Mr. Dwight Russell, P.E.
Municipal Solid Waste Permits Section – MC 124
Texas Commission on Environmental Quality
12100 Park 35 Circle; Bldg. F
Austin, Texas 78753

Re: Pescadito Environmental Resource Center - Webb County
Municipal Solid Waste (MSW) Permit Application No. 2374
Notice of Deficiency - Technically Complete Permit Application Supplement Number 5
Tracking No. 21876231; CN603835489/RN106119639

APTIM Environmental and Infrastructure, Inc. is in receipt of your letter dated October 23, 2017 in which you are asking for additional information and clarification related to our submittal of August 17, 2017.

GROUNDWATER MONITORING SYSTEM PLAN

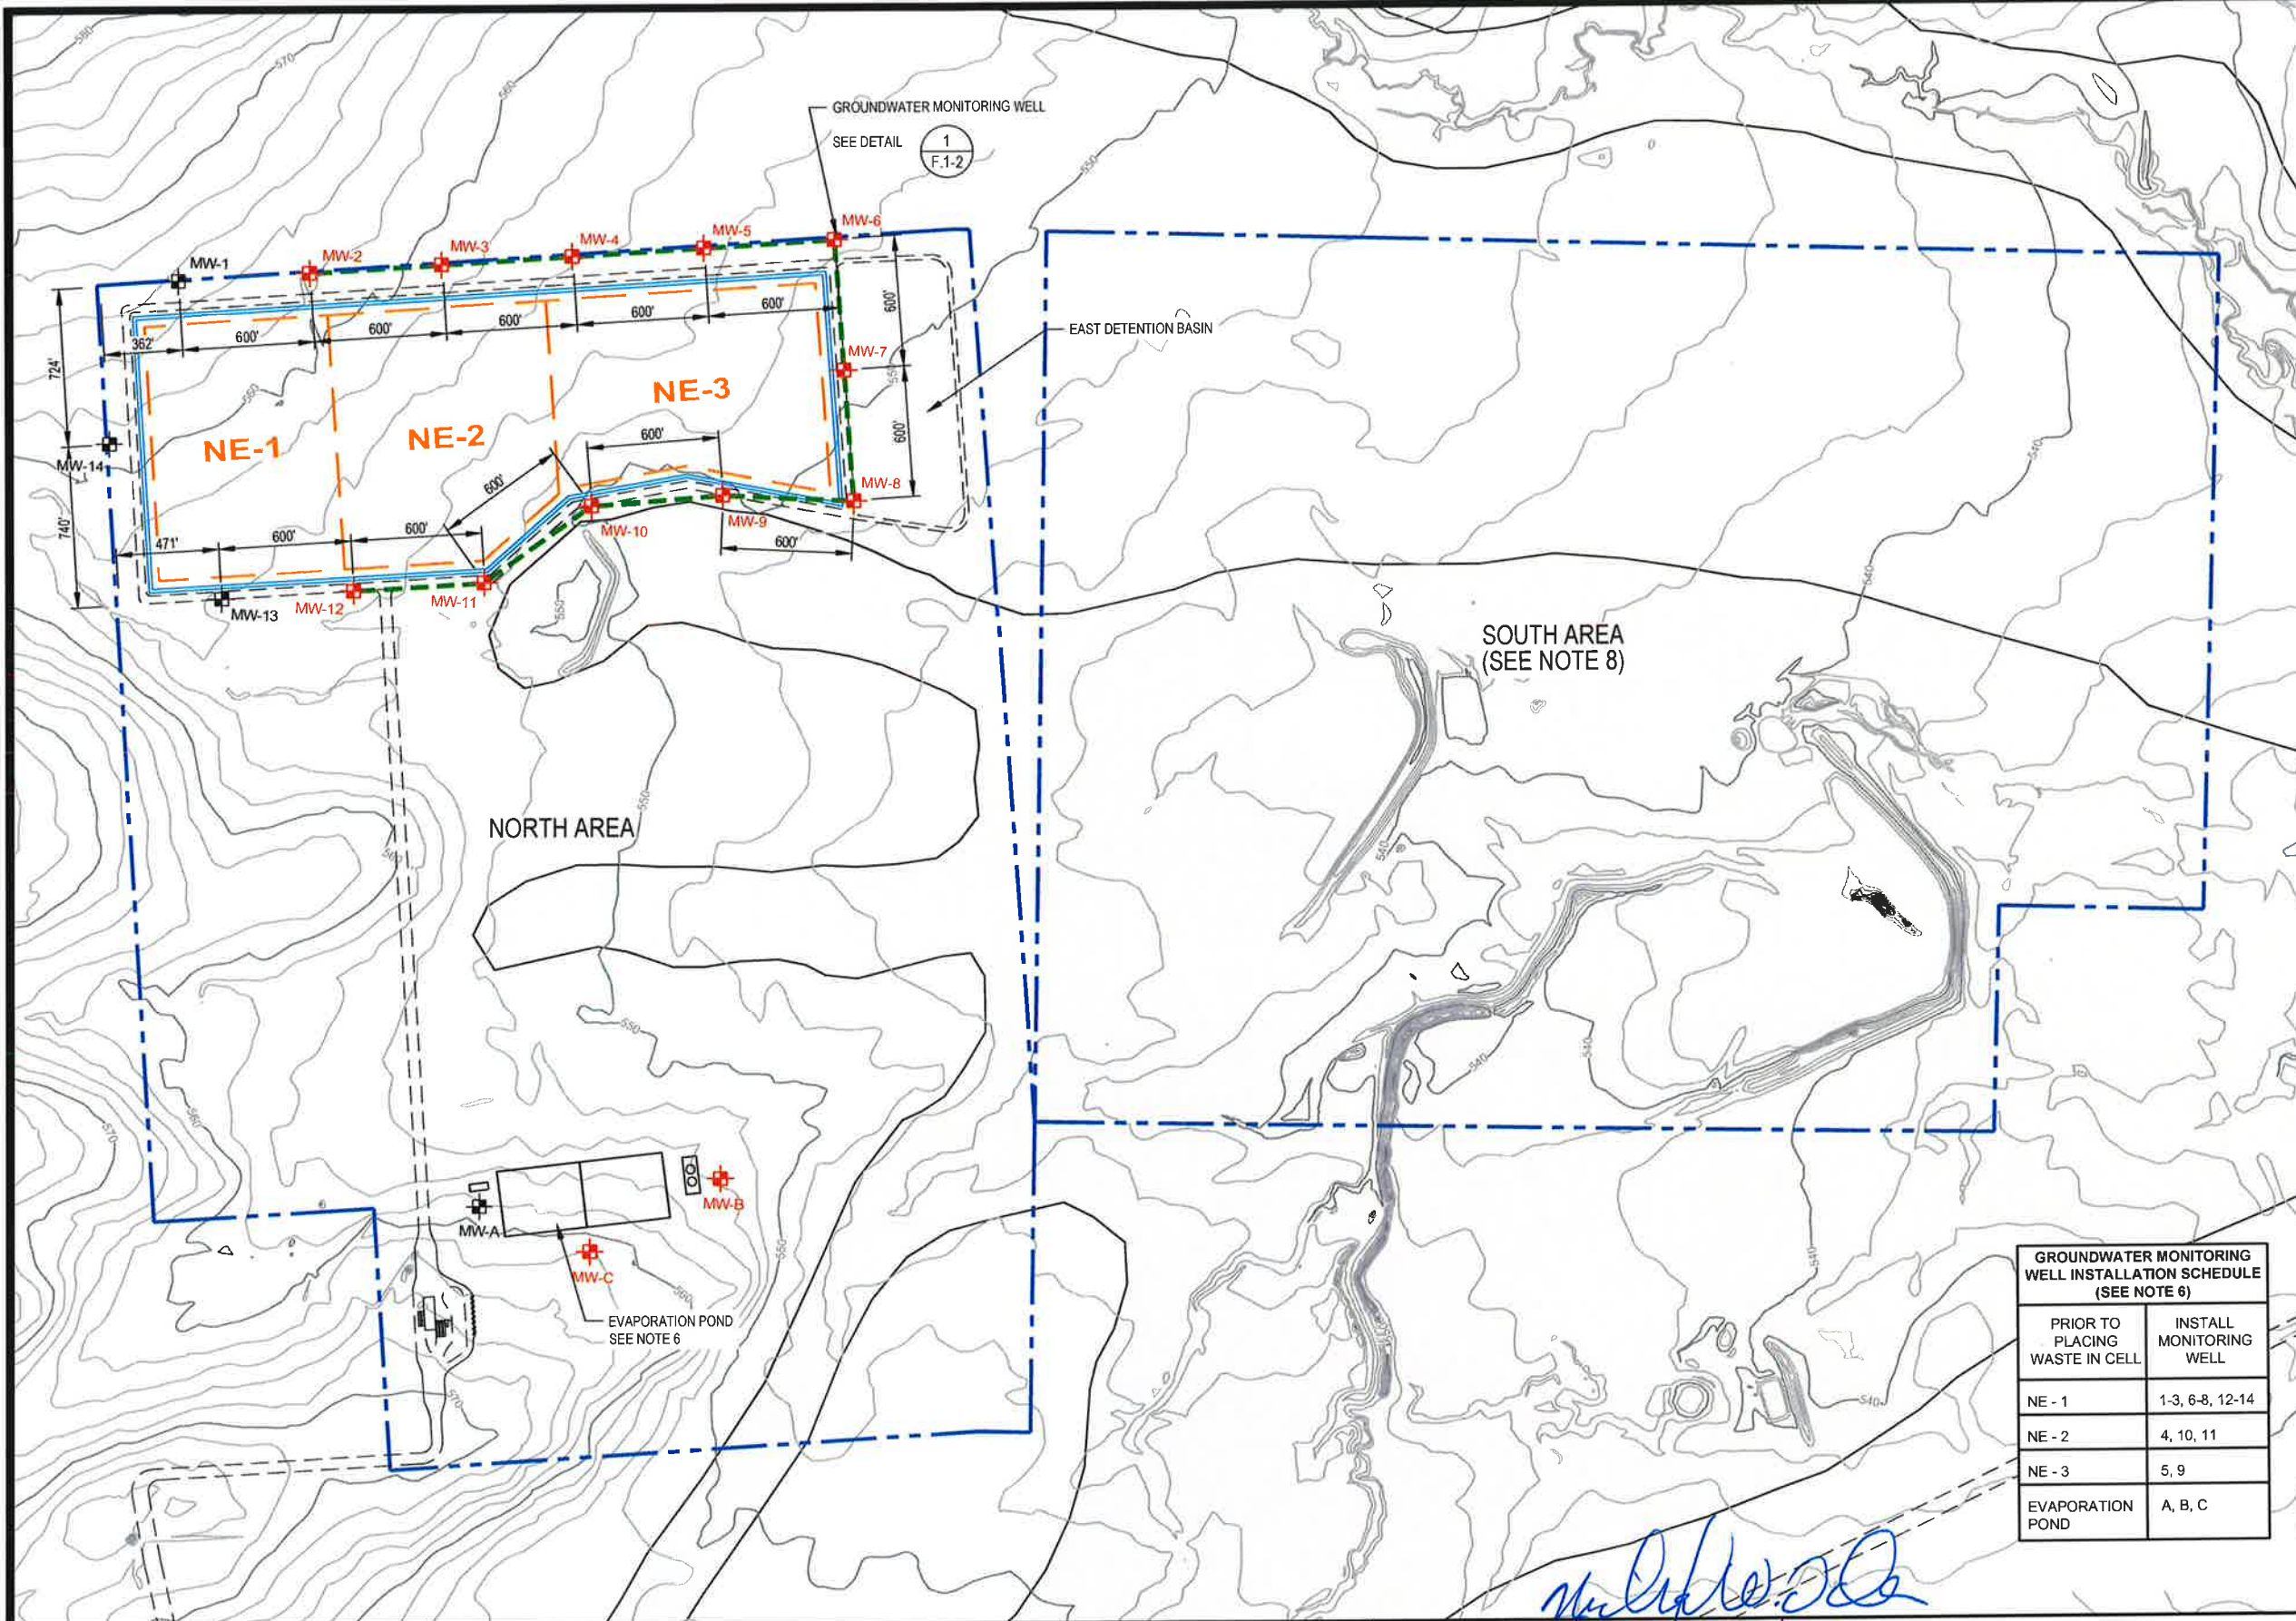
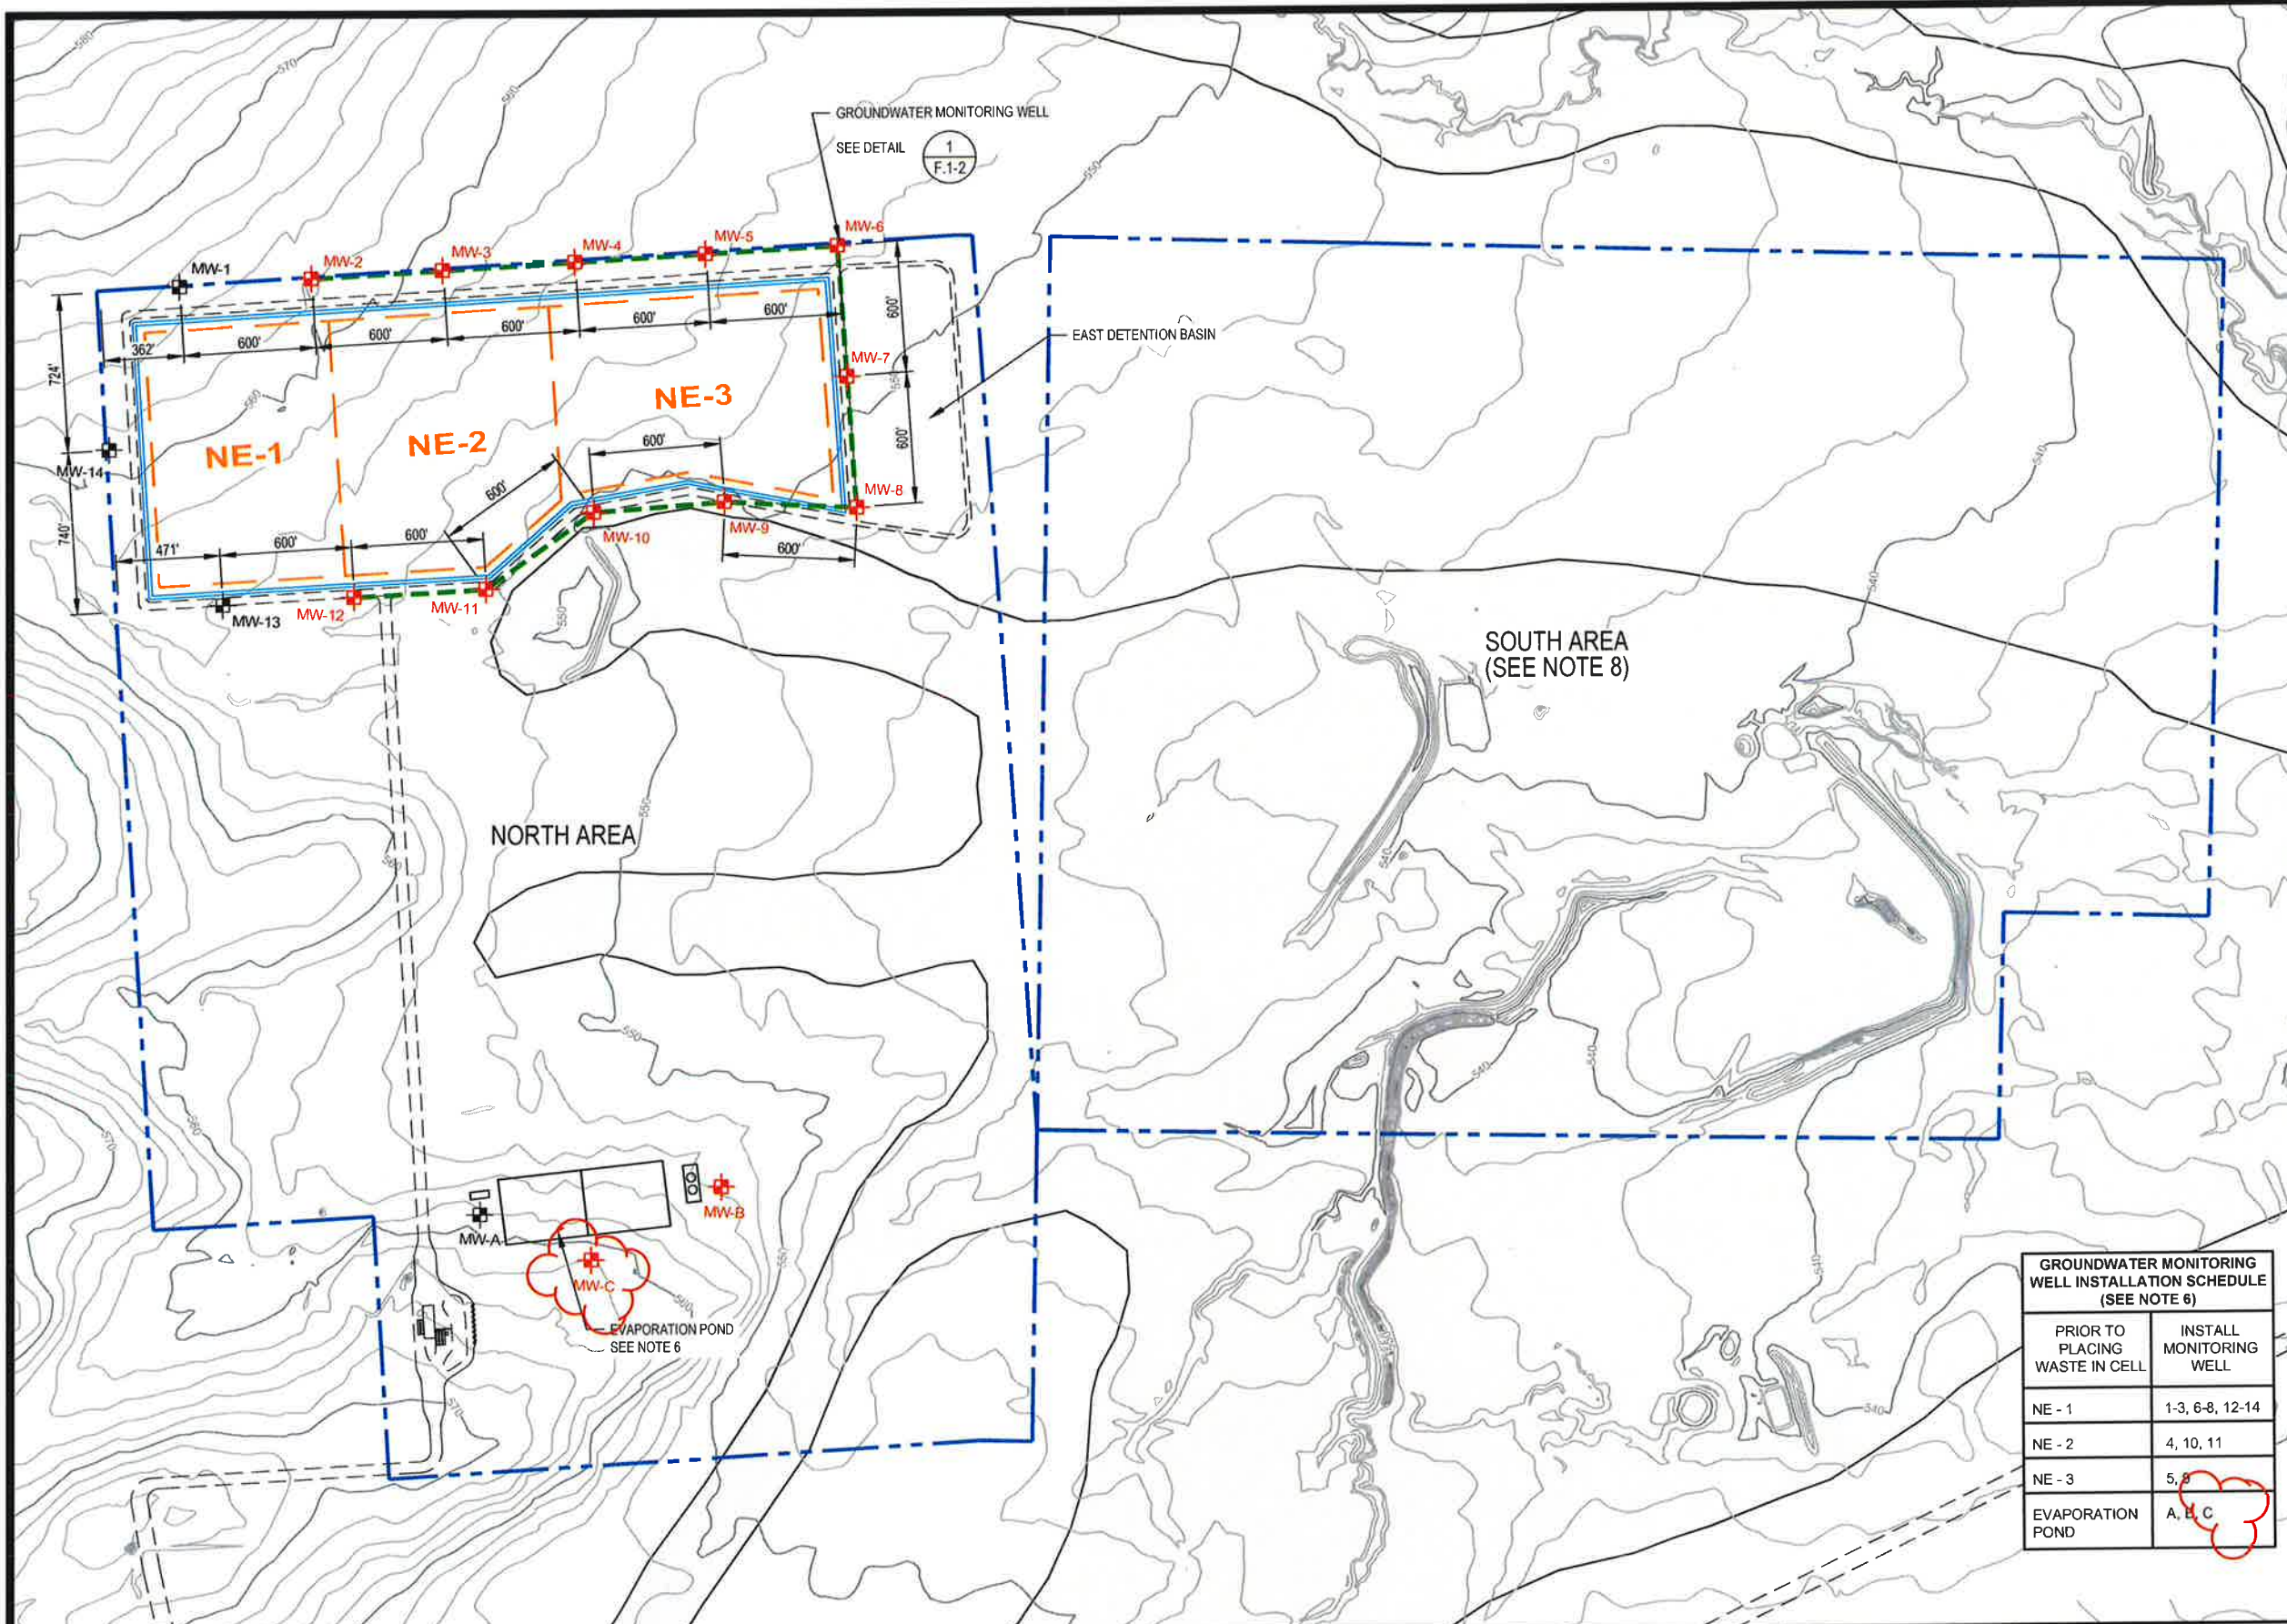
- 7) Note 6 on the Drawing III-F.1-1 describes monitoring wells MW-15, 16, and 17 to monitor the proposed leachate evaporation pond. The latest revisions to this drawing depict two wells to monitor the leachate pond (MW-A and MW-B. Please revise the drawing to be consistent. If fewer monitoring wells are being proposed

MW-C has been added on the west side of the pond location and Page 5 of Part III, Attachment III-F has been updated accordingly. Drawing III-F.1-1 and III-F.1-2 of Appendix III-F.1 have been updated to reflect this. The Closure and Post Closure Care cost estimate has been updated to reflect the additional groundwater monitoring well.
